**LINCOLN CITY/LANCASTER COUNTY PLANNING STAFF REPORT**

**P.A.S.:** Preliminary Plat #01012, West Park 2<sup>nd</sup> Addition

**PROPOSAL:** To preliminary plat 19 residential lots and one lot for an early childhood care facility.

<b>To:</b>	Tom Cajka, Planning Department
<b>From:</b>	Chad Blahak, Public Works and Utilities
<b>Subject:</b>	West Park 2nd Addition Preliminary Plat #01012 and Special Permit #1726
<b>Date:</b>	4/22/04
<b>cc:</b>	Randy Hoskins

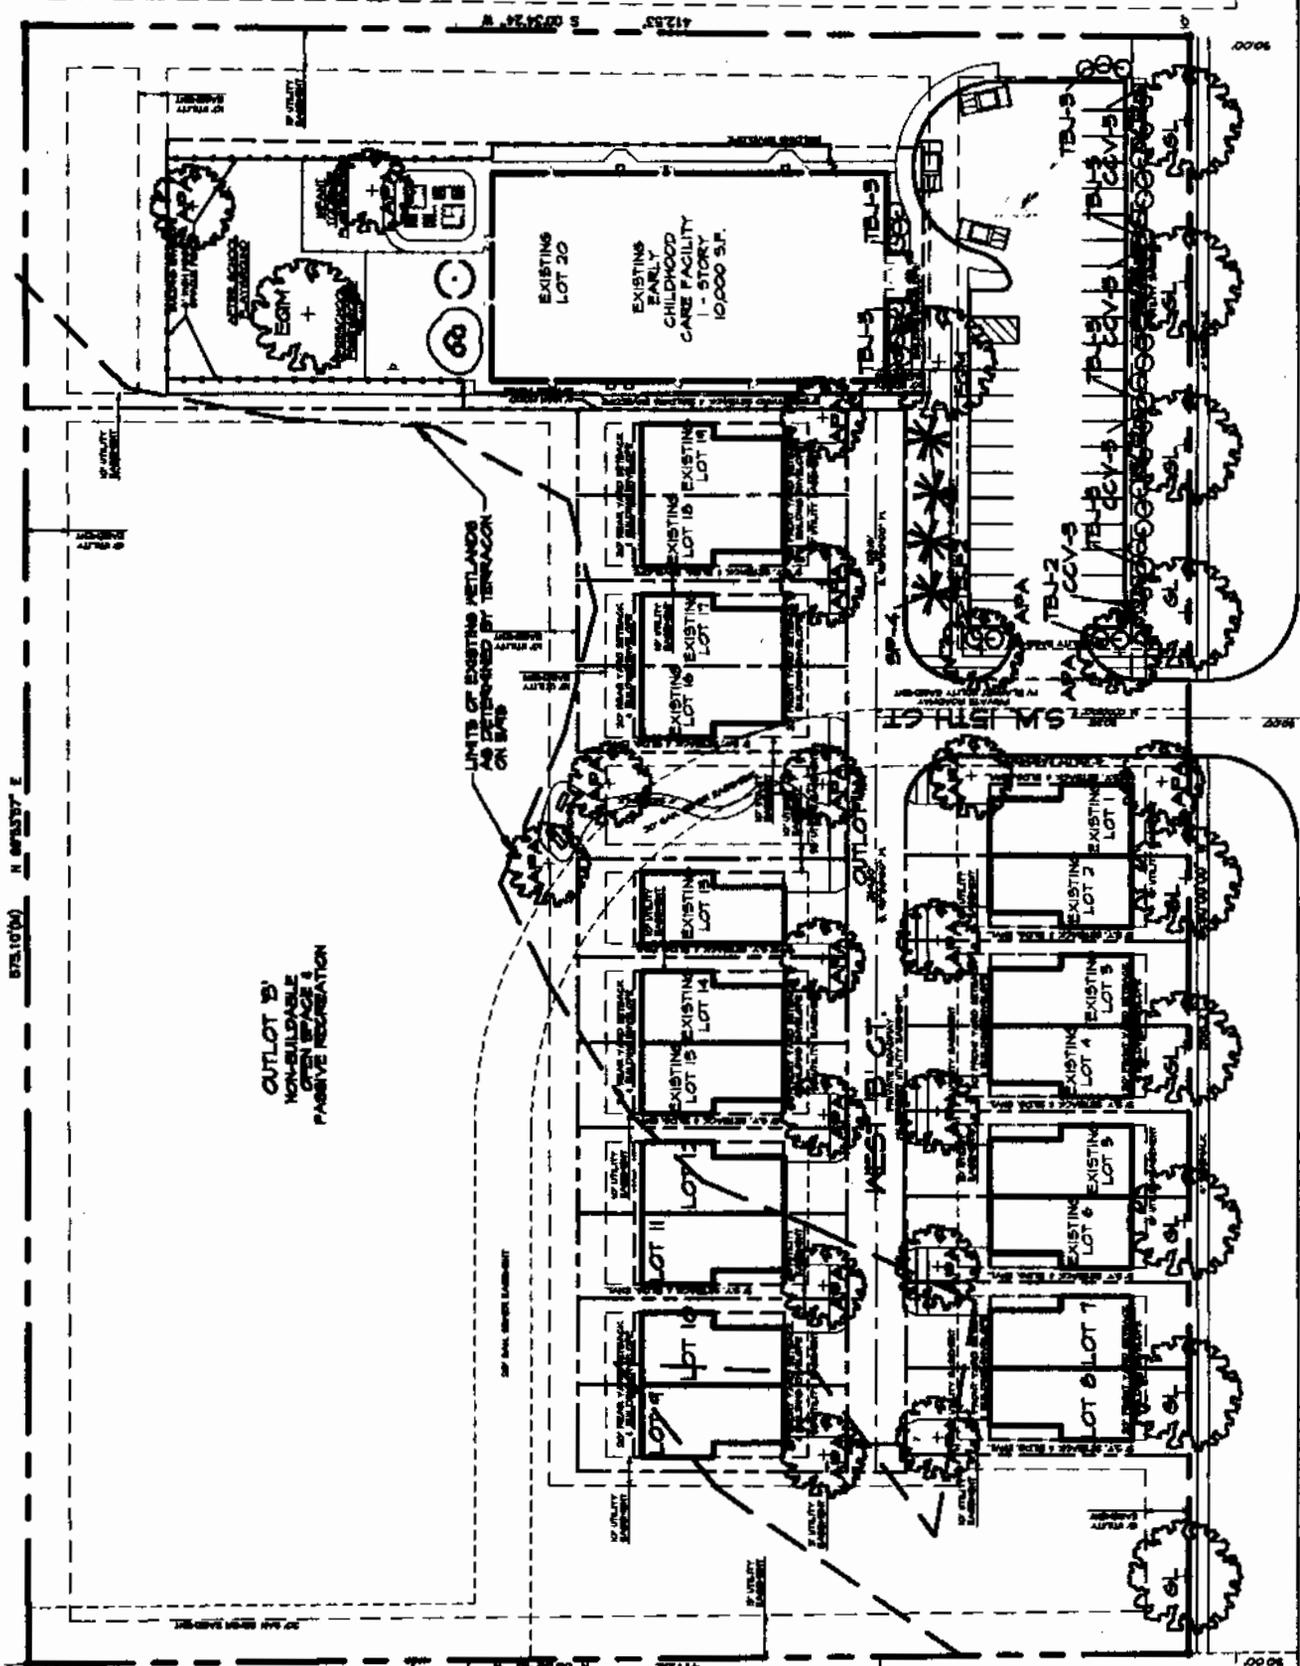
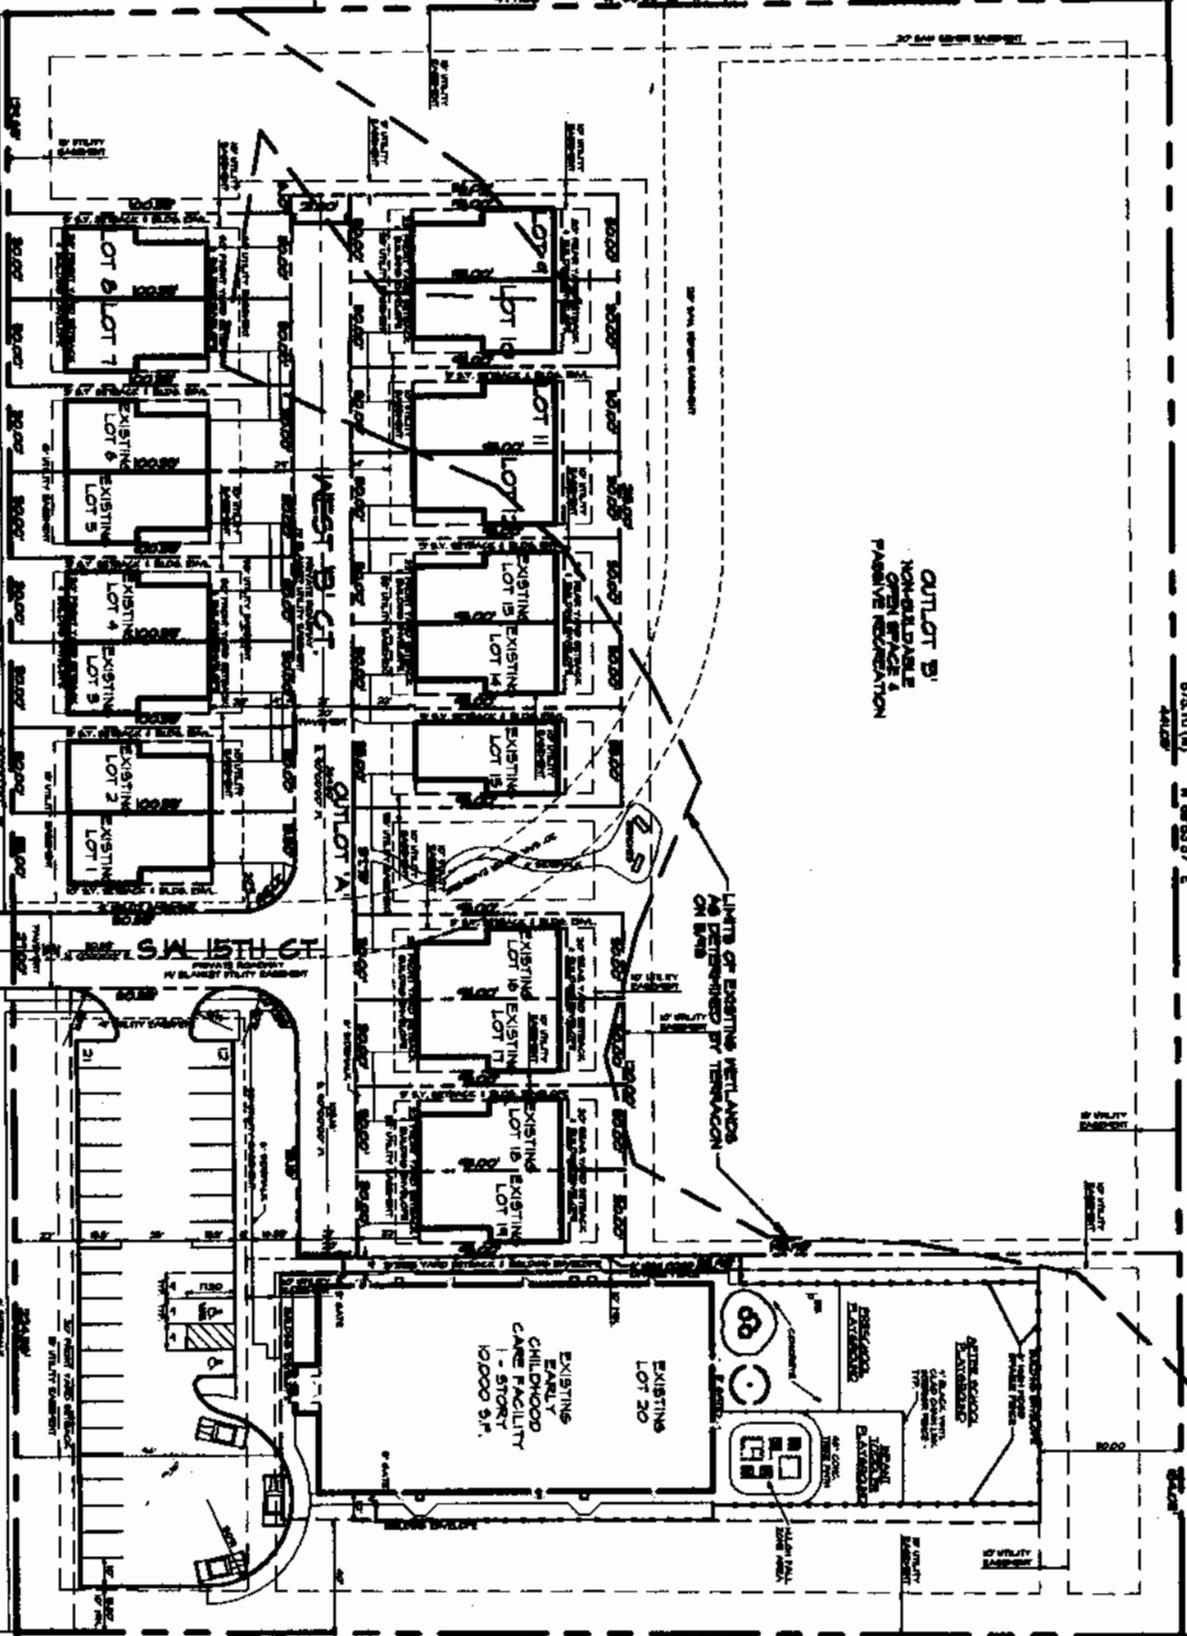
- The grading and drainage plan needs to be revised to reflect the current city storm sewer project in West A Street adjacent to this plat.
- The grading plan shows proposed contours that create low spots in the area north of the proposed and existing buildings that have no positive drainage. The grading plan needs to be revised to show positive drainage for these areas.
- Information needs to be provided showing that Lots 8 and 9 will not be flooded during the 100yr storm.
- A waiver of design standards for permanent turnaround geometry will need to be requested and justification will need to be provided for West B Court.
